APPLICATION NO.	FILING DATE	FIRST NAMED INVENTOR	ATTORNEY DOCKET NO.	CONFIRMATION NO.
10/653,823	09/03/2003	Toshihiro Takeuchi	SHM-14986	4117

Office Action Summary	Application No.	Applicant(s)	
	10/653,823	TAKEUCHI, TOSHIHIRO	
	Examiner	Art Unit	
	Nahid Amiri	3679

DETAILED ACTION

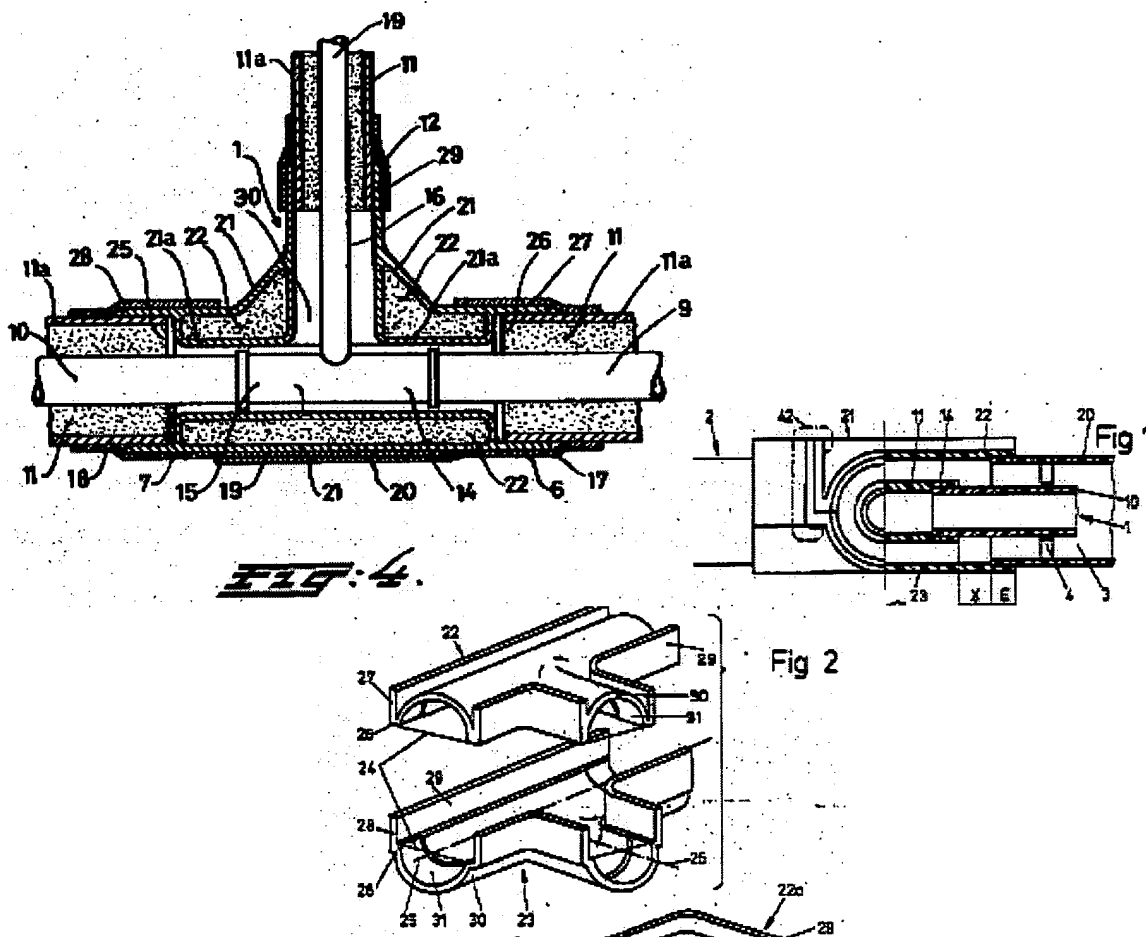
With respect to claim 1, At the outset, it should be noted that patentability in a product-by process claim is based on the resultant structure of the product and not the recited process steps. de Lange disclose a joint frame joint structure (Fig. 4) comprising a first frame member

(constituted by lower half portion of a pipe 7) of U-shaped cross section having a first sidewall, a second sidewall, a bottom wall and an opening; a second frame member (constituted by lower half portion of a pipe 11a), similar to the first frame member of U-shaped cross section having an opening, said second frame member having an end portion connected to at least one of the first sidewall and the second sidewall of the first frame member so as to define a joint between the first and second frame members; a reinforcing member (constituted by a combination of pipes 9 and 19) received in both the first and second members, said reinforcing member (9, 19) extending through said joint and into the first member a first predetermined length so as to have a free end adjacent said joint and extending in the second frame member a second predetermined length so as to have another free end adjacent the joint; a plate member (constituted by a combination of upper half portions of the pipes 7 and 11a) closing the openings of the first and second frame members (constituted by lower half portions of pipes 7 and 11a) to form closed cross sections; and a foamed resin filling spaces (11) defined by the plate member, the first and second frame member and the reinforcing member (9, 19). De Lange does not disclose that the reinforcing member is formed from one piece. Kunz et al. teaches a pipeline system (Figs. 1-2) having one piece reinforcing member (constituted by a pipe 10) extending into the first frame member and the second frame member by predetermined lengths at a joint of the first frame member and the second frame member. It would have been obvious to one of ordinary skill in the art at the time of invention was made to form the reinforcing member of de Lange from one piece as taught by Kunz et al. in order to make a conventional pipeline. With respect to the added process recitation pertaining to how the foamed resin is formed, the resultant combination possesses a "foamed resin" and that is all that is necessary to meet the claim.

With respect to claim 2, de Lange discloses (Fig. 4) that the reinforcing member is generally T-shaped.

With respect to claim 11, de Lange discloses (Fig. 4) that the second frame member having an end portion connected to one of the first and second sidewalls of the first frame member; and wherein the one of the first and second sidewalls of the first frame member has a hole formed therein; and wherein the hole is larger than a cross-sectional dimension of the

reinforcing member (9, 19) such that the reinforcing member (9, 19) may freely extend through the hole in the first frame member, and whereby an annular space surrounding the reinforcing member and the one of the first and second sidewalls of the first member at the hole being filled with the foamed resin (11).
